In the Matter of)	
)	July 25, 2006
AMERGEN ENERGY COMPANY, LLC)	
)	Docket No. 50-0219-LR
(License Renewal for the Oyster Creek)	
Nuclear Generating Station))

SUPPLEMENT TO PETITION TO ADD A NEW CONTENTION

Subject: Oyster Creek, Drywell Liner
Integrity Assurance and Monitoring Frequencies

Figure 1

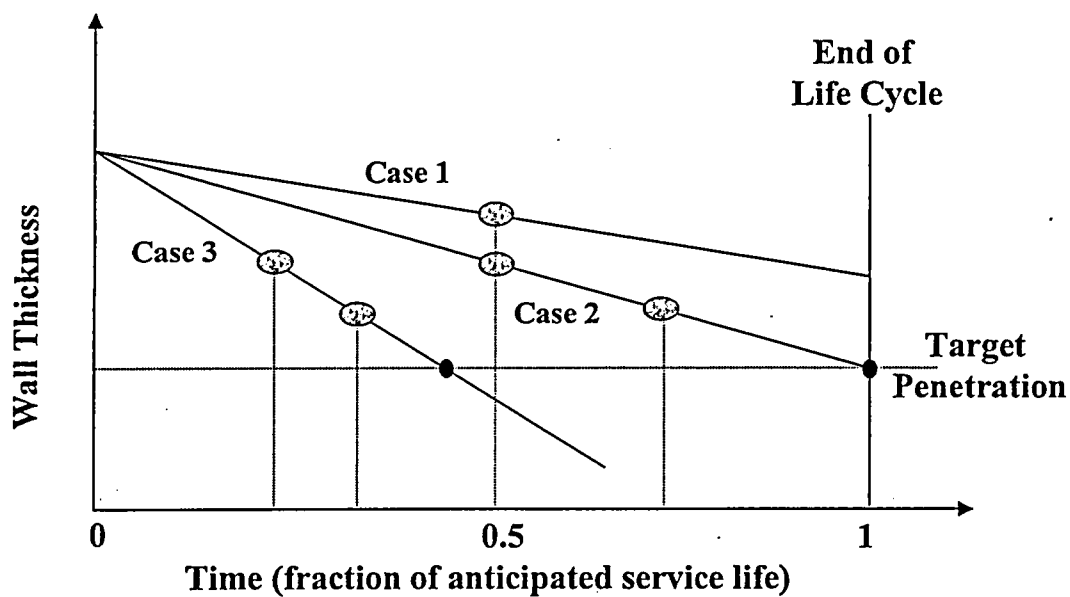
In order to gauge the remaining service life of a corroding structure one needs to know the inherent corrosion (or pitting) rate. It is generally impossible to assess this rate a priori on the basis of either laboratory measurements or theoretical calculations. Hence, corrosion rates need to be established in the field under service conditions. A commonly accepted procedure is demonstrated in Figure 1. A structure such as a vessel or a pipeline has a given nominal wall thickness and is subject to corrosion. The useful service life is determined by a minimum allowable wall thickness, depending on operating conditions, the allowable "target penetration".

In Case 1 the prevailing corrosion rate (loss of wall thickness with time) appears to be low enough such that at the end of the projected service life the remaining wall

thickness is above the minimum target. In this case in service wall thickness measurements (also called direct assessment), for instance by UT technology or an intelligent pig (in case of a pipeline), would be carried out at half of the remaining service life. If the corrosion (penetration) rate can be reaffirmed, one would likely not verify the integrity of the structure by direct assessment again until the end of the service life. However, one would continue to monitor ongoing corrosion or changes of the environment, which could result in a change of the corrosion rate, by other means, such as corrosion coupons or sensors, or in the case of Oyster Creek by moisture monitors (also referred to a indirect assessment ¹⁾).

In Case II, the known corrosion rate predicts the minimum target wall thickness to be reached at the end of the service life. In this case verification would occur at the half-life of the structure, and again half way between it and the end of the service life. Simultaneously, changes of the environment, or changes in corrosion rate would be monitored continuously. In this case the latter is all the more important.

In Case III, the corrosion rate is such that the structure would have to be abandoned prior to the expected full service life. Nevertheless, the structure would be routinely examined in order to obtain as long a service life as possible. This situation prevailed at Oyster Creek in 1992, prior to preventive measures having been applied (Ref. 2)
